UNITED STATES PATENT AND TRADEMARK OFFICE

APPLICATION NO.	FILING DATE	FIRST NAMED INVENTOR	ATTORNEY DOCKET NO.	CONFIRMATION NO.
09/398,652	09/17/1999	WILLIAM A. SAMARAS	042390.P5120D	1359

Office Action Summary

DETAILED ACTION

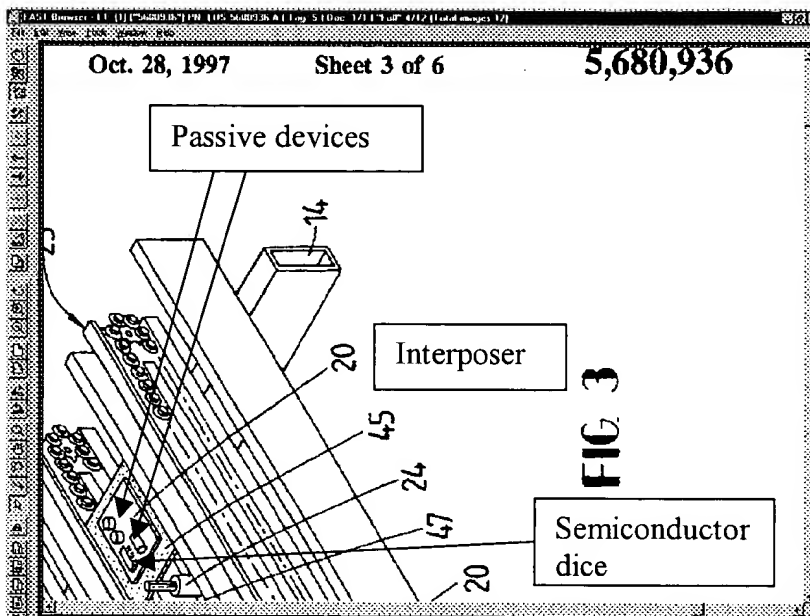
Beers discloses coupling at least one passive device (see annotated Fig. 3 below) thereby regulating voltage and current to the electronic dice.
